**DIRECT TESTIMONY AND EXHIBITS OF****ANTHONY M. SANDONATO****ON BEHALF OF****THE SOUTH CAROLINA OFFICE OF REGULATORY STAFF****DOCKET NO. 2019-224-E****DOCKET NO 2019-225-E****IN RE: SOUTH CAROLINA ENERGY FREEDOM ACT (HOUSE BILL 3659)****PROCEEDING RELATED TO S.C. CODE ANN. SECTION 58-37-40 AND****INTEGRATED RESOURCE PLANS FOR DUKE ENERGY CAROLINAS, LLC****AND DUKE ENERGY PROGRESS, LLC****Q. PLEASE STATE YOUR NAME, BUSINESS ADDRESS AND OCCUPATION.**

**Review of Duke Energy Carolinas, LLC  
2020 Integrated Resource Plan  
Docket No. 2019-224-E**

The South Carolina Office of Regulatory Staff (“ORS”) provides this review of Duke Energy Carolinas, LLC’s (“DEC” or “Company”) 2020 Integrated Resource Plan (“IRP”) filed September 1, 2020, in Docket No. 2019-224-E. In this report (“ORS Report”), when discussed collectively, DEC and its affiliated utility, Duke Energy Progress, LLC (“DEP”), will be referred to as “Duke Energy.”

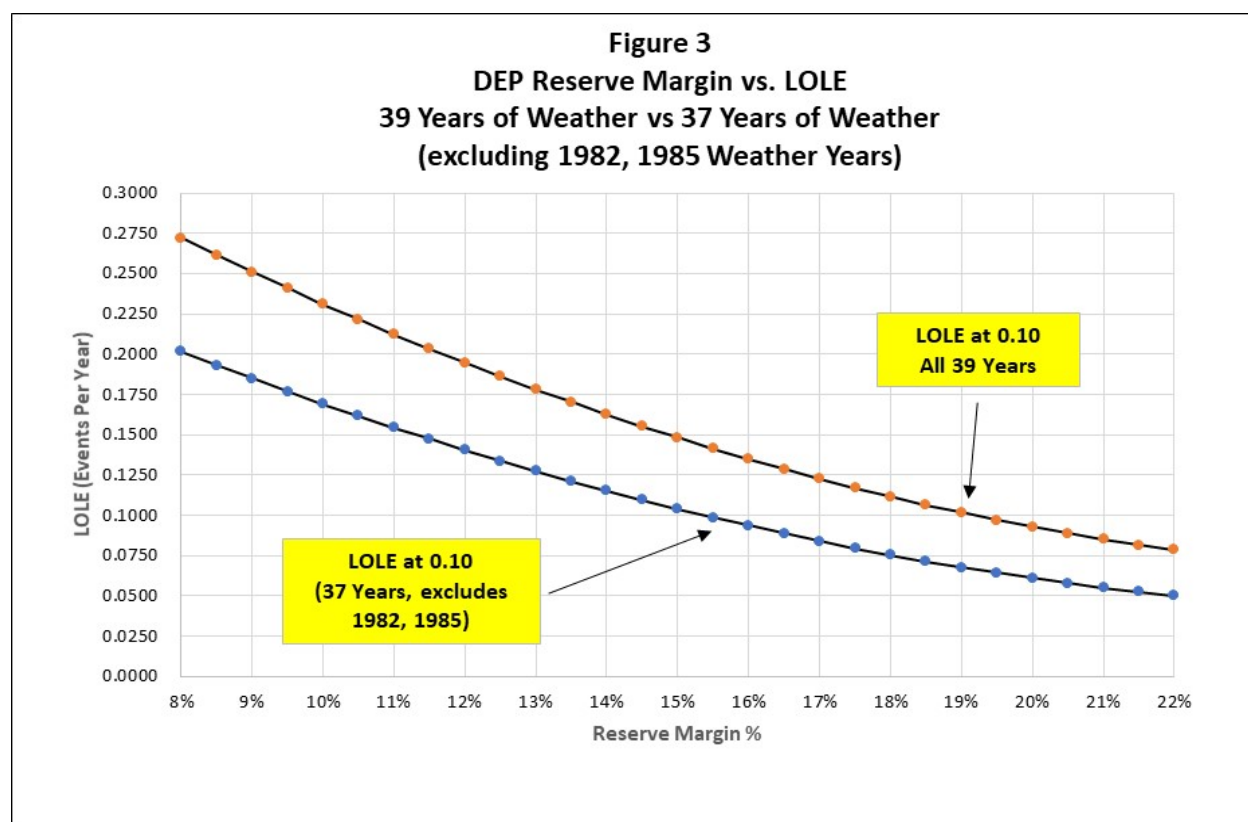
ORS's review of the Company's analysis indicates that the approach used was not unreasonable, though we do have some concerns regarding the ability of the model to accurately measure the effect of extreme low temperatures on load and the impact that may have on the estimation of LOLE.

This issue has a significant impact on the level of required winter reserves needed to maintain an LOLE of 0.10. To examine this impact, ORS recalculated the LOLE analysis developed by the Company under two alternative scenarios: one in which 1982 weather is removed, and another in which both 1982 and 1985 weather are removed from the analysis. The purpose of this analysis is to develop an understanding of the importance of extreme cold weather years on the overall LOLE results, not to suggest or recommend that the LOLE analysis exclude these extreme weather years. The weather in 1982 and 1985 reflected very low winter temperatures. The lowest winter temperatures in the 39-year data base occurred in 1985 for DEP.

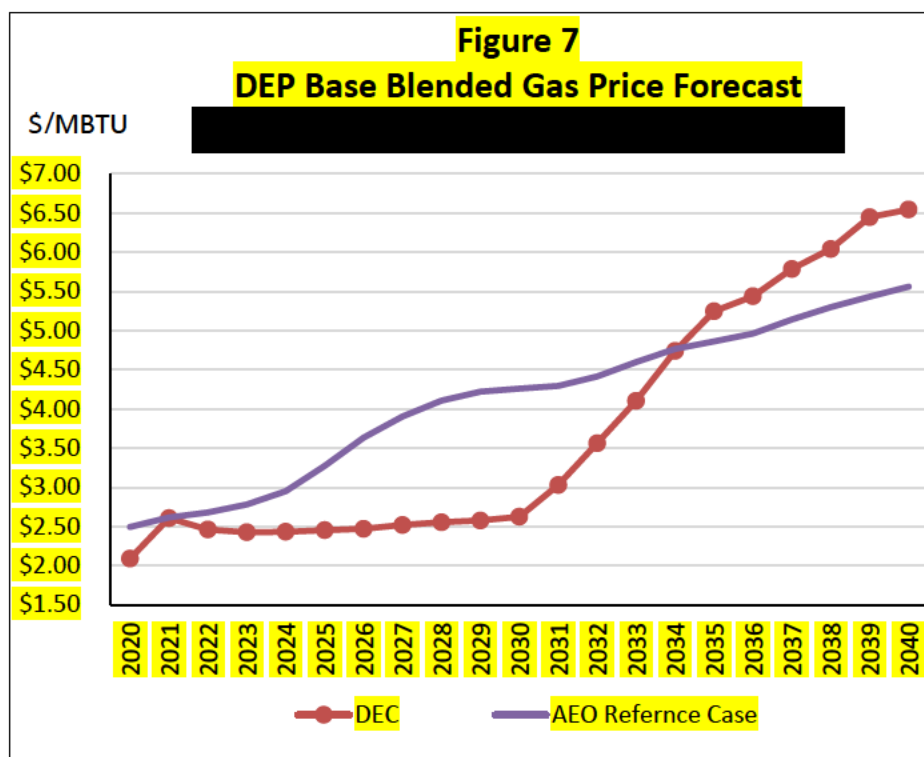
The Company's natural gas price forecasts are consistently lower than the consensus forecasts in all three (3) cases by a small amount over the period of 2021 to about 2035. After that the DEP forecast actually exceeds the consensus forecast by a small amount in all three (3) cases. ORS recognizes that the future is unknown and that natural gas price forecasts have been lowered considerably over the last ten years. While DEP's forecasts do appear to be a little low over the planning horizon, the important question is whether DEP's forecasts are outliers when compared to the other forecasts, and the answer is no. Some of the other comparable forecasts are actually lower or are close to DEP's forecast over the planning horizon.

While DEP's forecasts do not appear to be unreasonable, there may be an opportunity for improvement. The development of the Company's base gas price forecast is illustrated in the following graph, which shows that the DEP Base forecast is equivalent to the market forecast (NYMEX) until 2030, then trends into the fundamental forecast (██████████) until 2035, and follows the fundamental forecast thereafter.

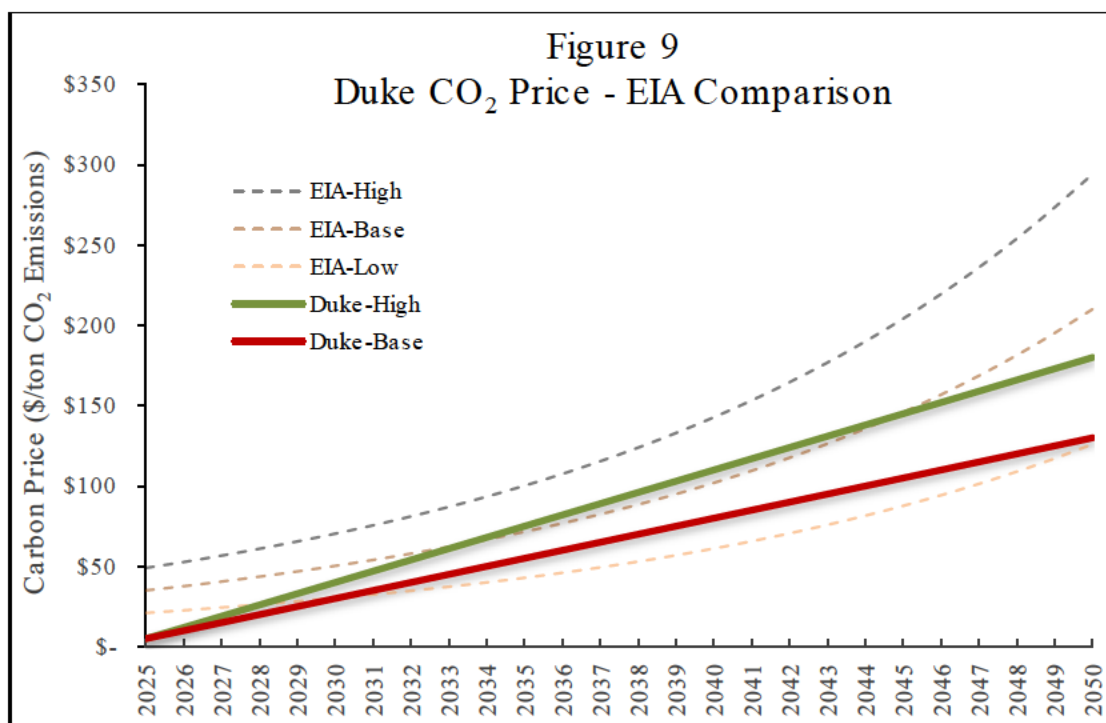
The following figure compares Duke Energy's forecasts to EIA projections and shows that Duke Energy's forecasts are reasonably consistent with EIA's.<sup>73</sup>

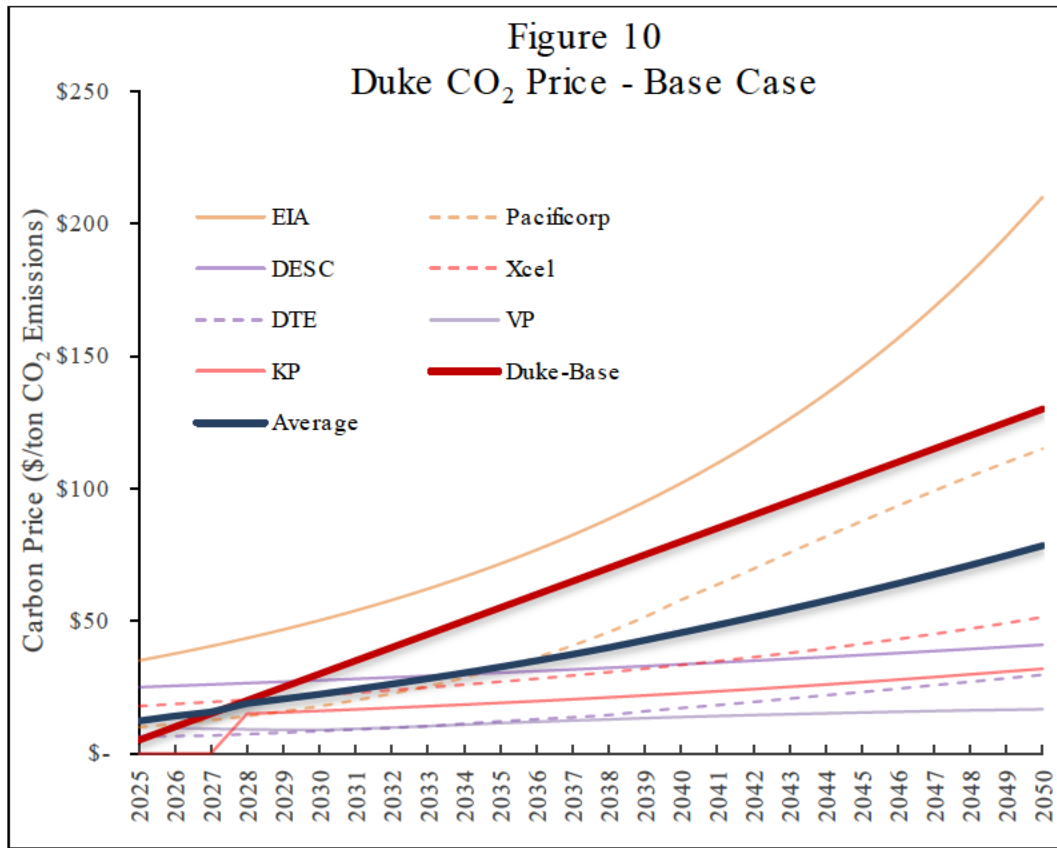
The following figure compares Duke Energy's Base CO<sub>2</sub> forecast to other publicly available base CO<sub>2</sub> utility forecasts and shows that Duke Energy's forecasts are also reasonably consistent with those forecasts, though in fact, Duke Energy's forecast is higher than the average of the forecasts. The other utility forecasts include PacifiCorp,<sup>74</sup> DESC,<sup>75</sup> Xcel Energy,<sup>76</sup> DTE Electric,<sup>77</sup> Virginia Power,<sup>78</sup> and Kentucky Power,<sup>79</sup> and the average of each forecast (including Duke Energy's).

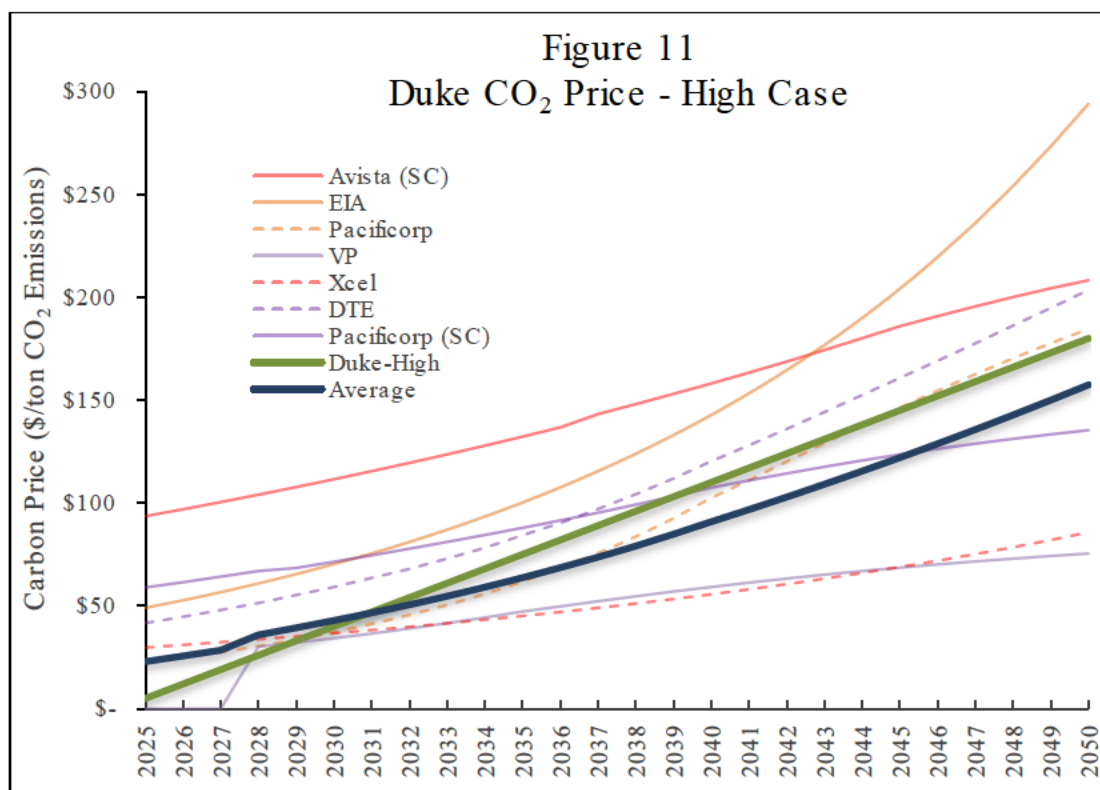
Lastly, the following figure compares Duke Energy's High CO<sub>2</sub> forecast to the other publicly available high CO<sub>2</sub> utility forecasts and shows that Duke Energy's forecast is once again reasonably consistent with the other forecasts, though in fact, Duke Energy's forecast is higher than the average of the forecasts.
